42 HONEYSUCKLE DRIVE COTTAGE CREEK PRECINCT NEWCASTLE

NEWCASTLE CITY COUNCIL
DEVELOPMENT APPLICATION

ARCHITECTURAL DESIGN RESPONSES

MAY 2018
REV B

1 Southern facade planters and green facade on GF-Typical
Scale: 1:50

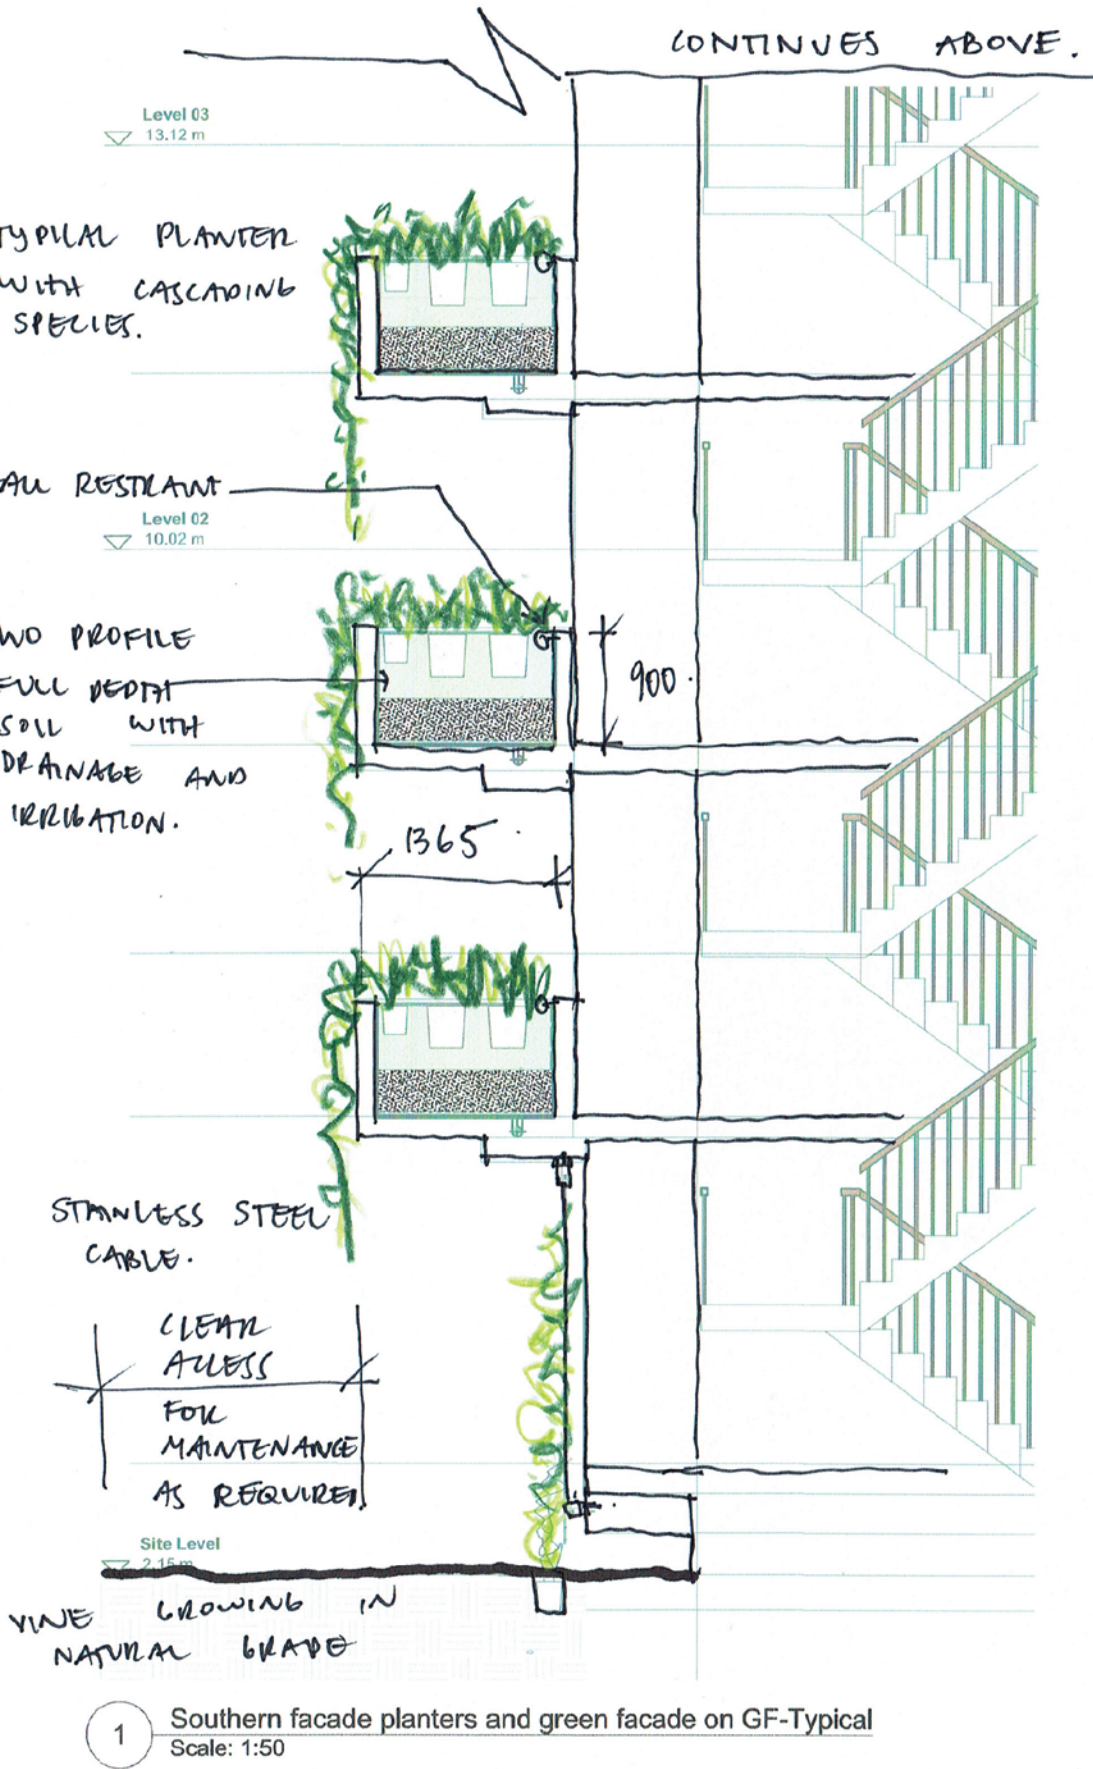
Provide a design verification statement from a green wall expert to ensure suitability of the system proposed.

Refer to attached letter from Green wall expert which refers to the suitability of the proposed system.

- The construction phase of the planter box installation and the green façade system is uncomplicated and is managed by light weight technology for planters, soil and drainage elements. These systems have been completed previously to a high standard and only require suitable coordination with the given builder.

- The Planters are of a high-quality for visual impact and longevity. Irrigation and drainage will directly service these planters for optimum horticultural results managed with a documented maintenance strategy.

- Plants selected will be suitable for south and east aspects. Jointly SDC / Junglefy will collaborate our Horticultural experience to provide the best solution for this location. We have previously collaborated on significant projects such As One Central Park, Sydney to provide similar solutions.

3.1 RESIDENTIAL AMENITY:

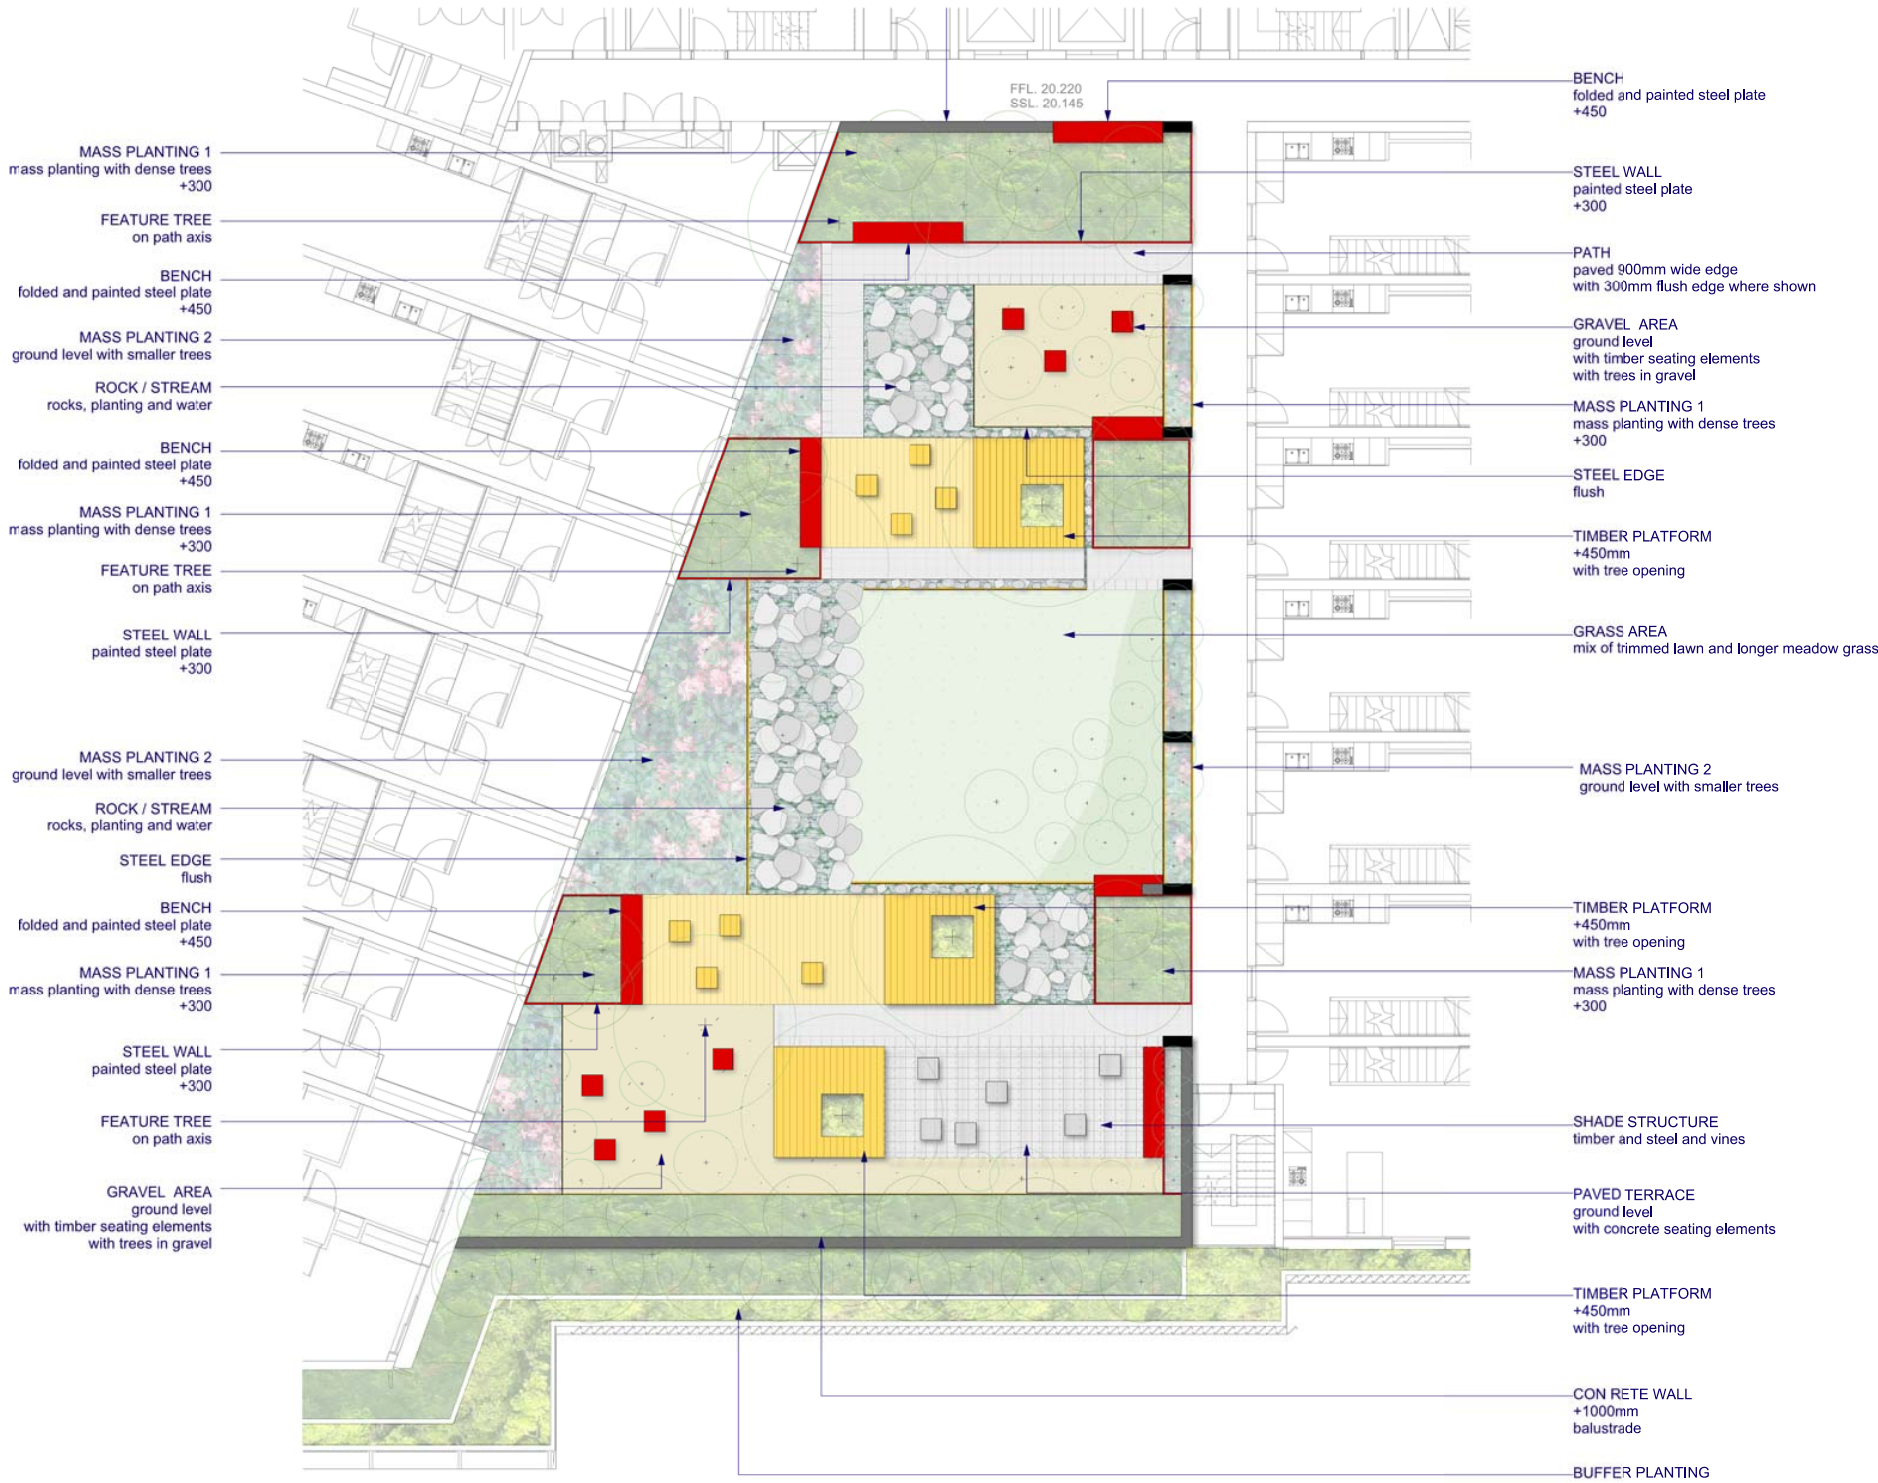
‘Provide amended plans / additional information which confirms: the area of communal open space provided, including whether residents are also given access to hotel facilities including the gym and library / lounge’

See SDC Landscape architects plans illustrating the L05 residential communal space, with larger turfed areas, seating areas for gatherings - large or small and a low key facility for BBQ.

It should also be noted that the private gardens within the courtyard have been removed to allow for a larger communal amenity. The gardens where situated off the bedrooms and would have seen very little use due to overlooking and solar access. The bedrooms facing the courtyard, as with all windows facing the courtyard, will be fitted with angular fixed louvres to provide privacy whilst still maintaining daylight and ventilation.

LEVEL 05 & 07

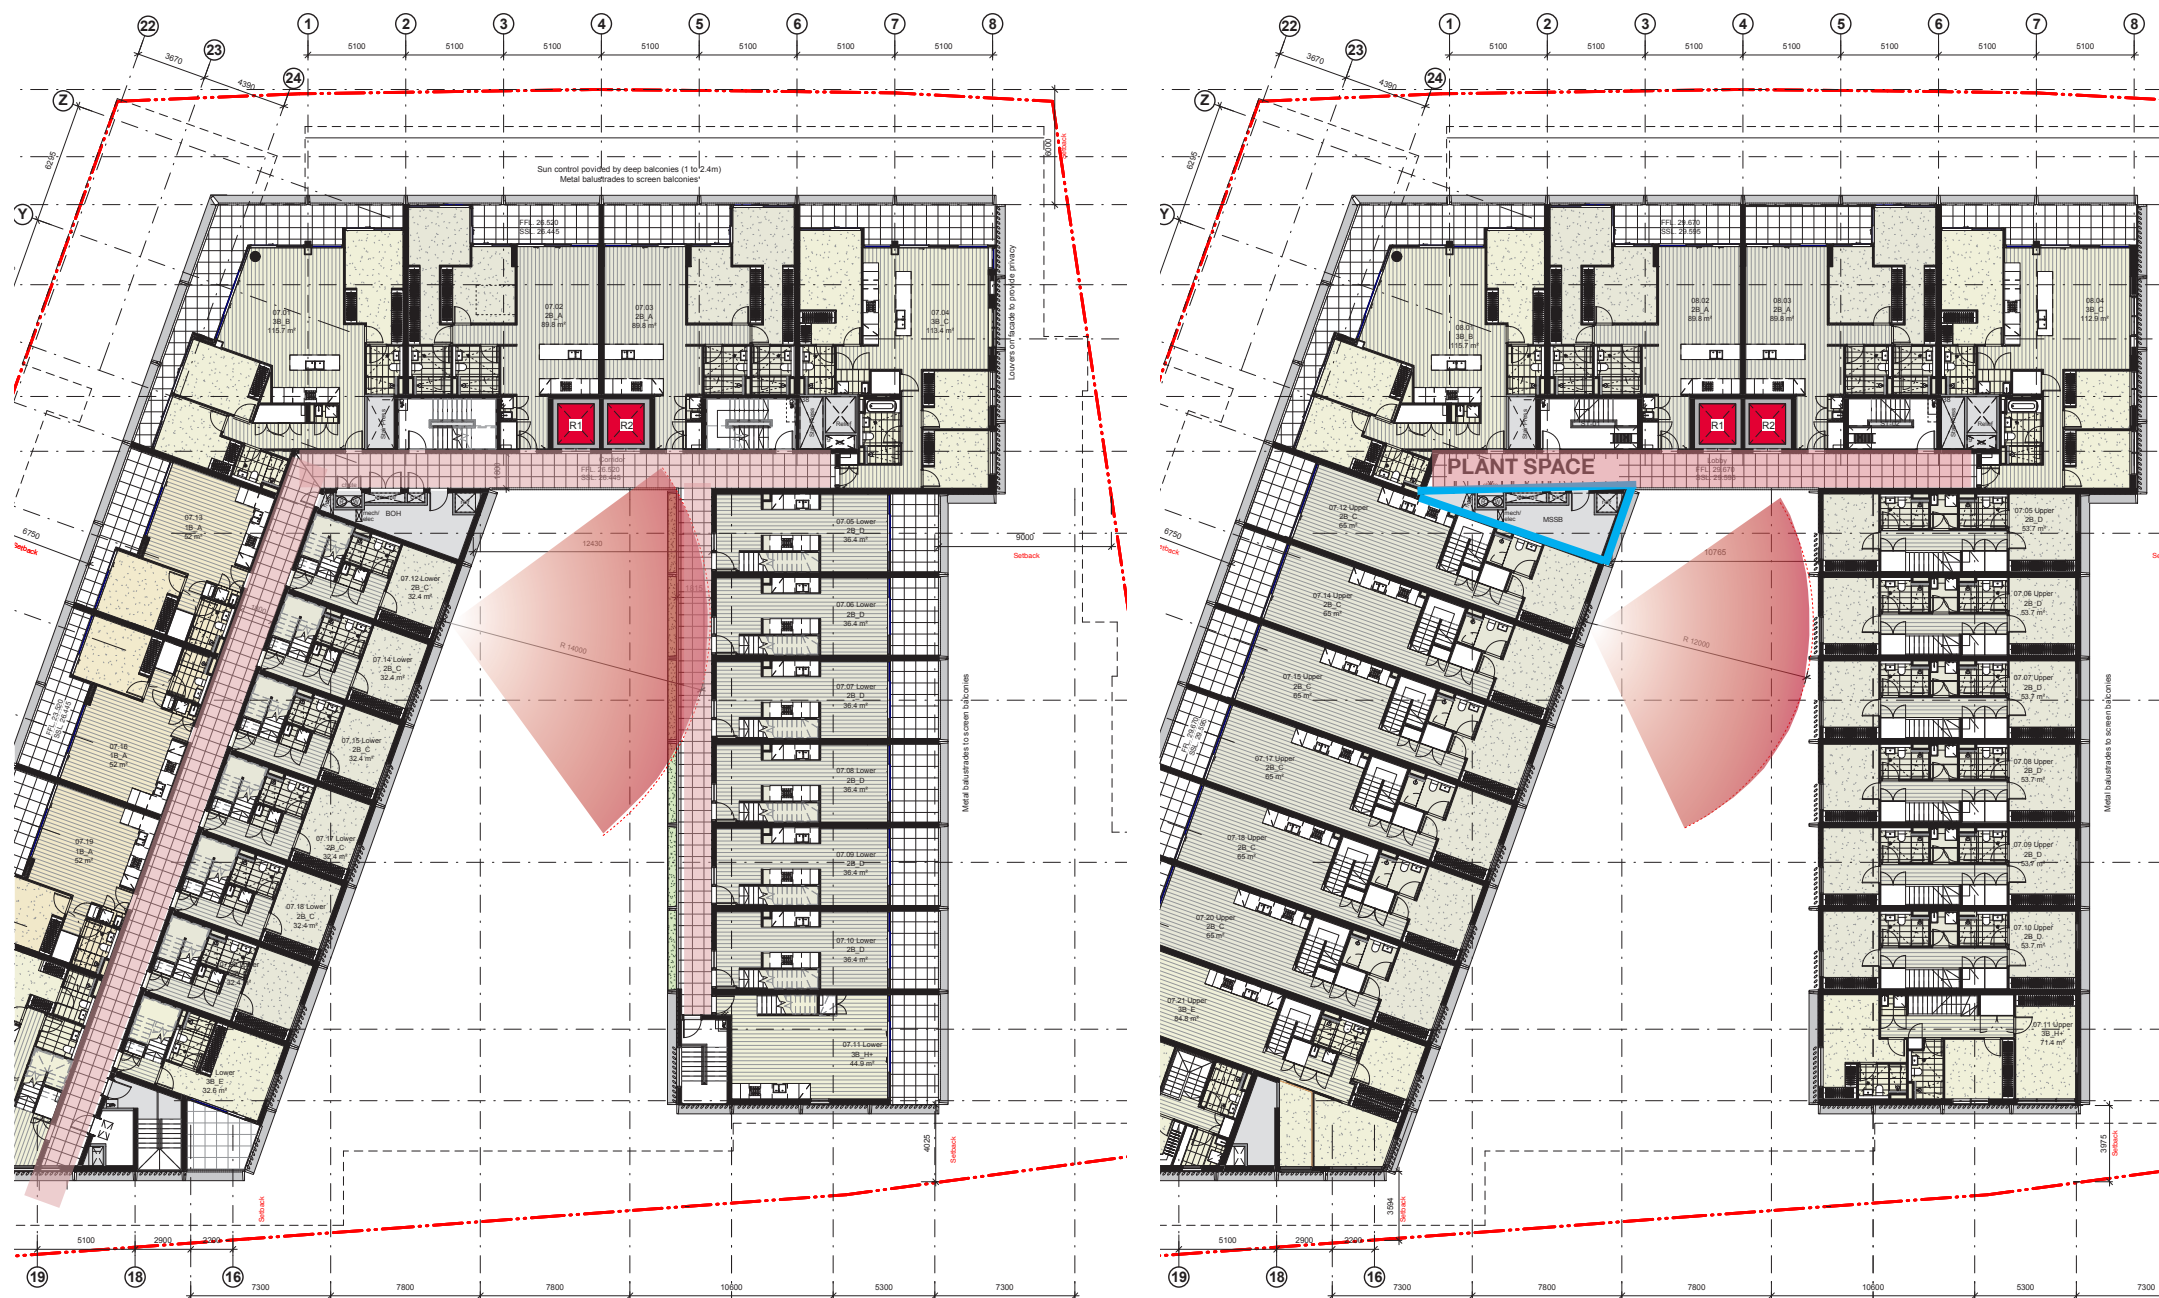
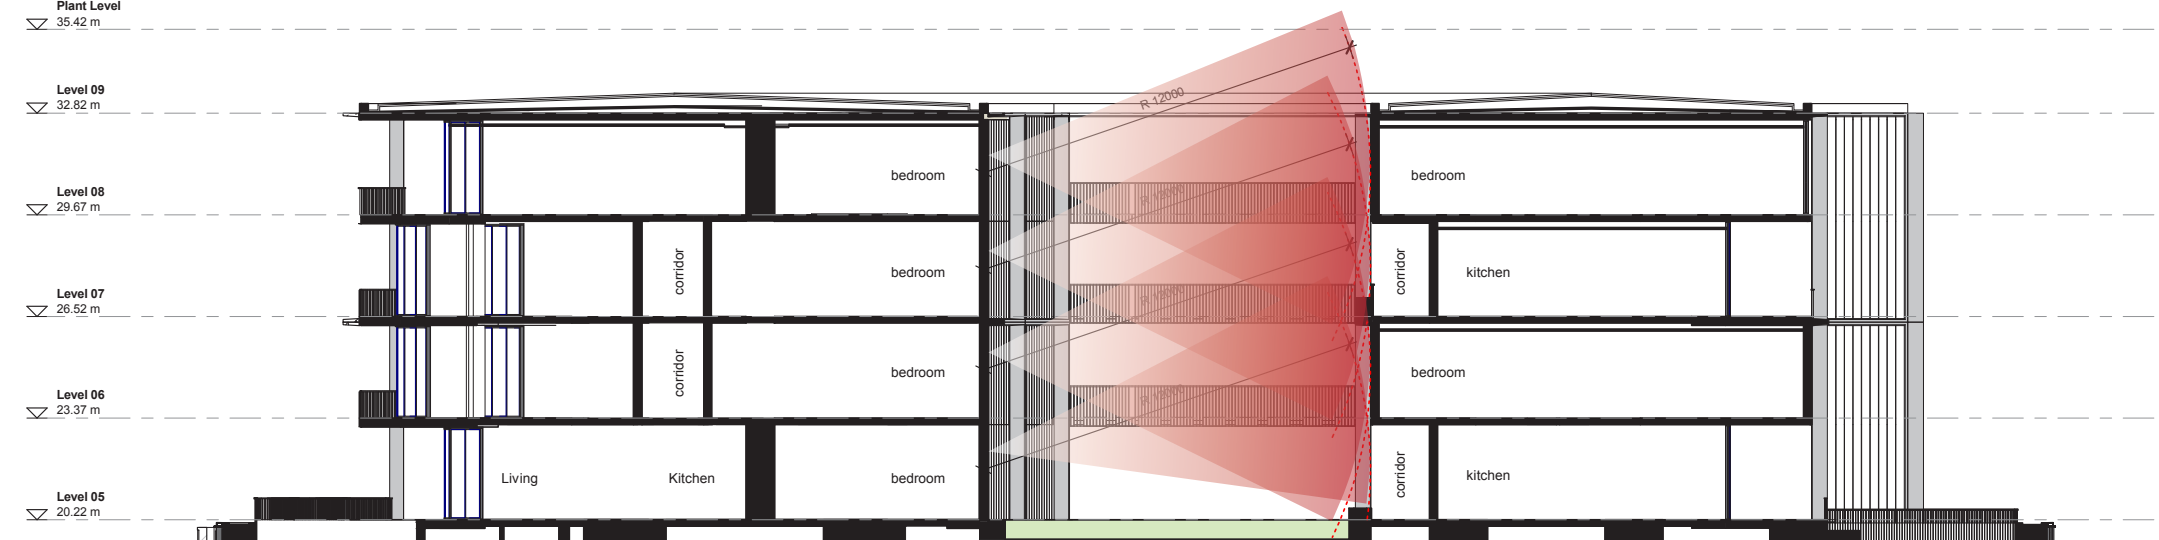
Level L05 is a communal space, the interface between opposing apartments varies from 10.7m (habitable room to plant room space/ blank wall) to a minimum of 12m from habitable room to habitable room.

Although the communal space is at level L05, we consider that the 12m separation is appropriate because the podium forms a base level on which the apartments are only four storeys high; because the design provides for an interface including deep-rooted podium planting, any increase in separation would not provide a significant increase in residential amenity.

Levels L05 and L07 the apartments facing the open corridors will also provide further separation and these will be screened using planters.
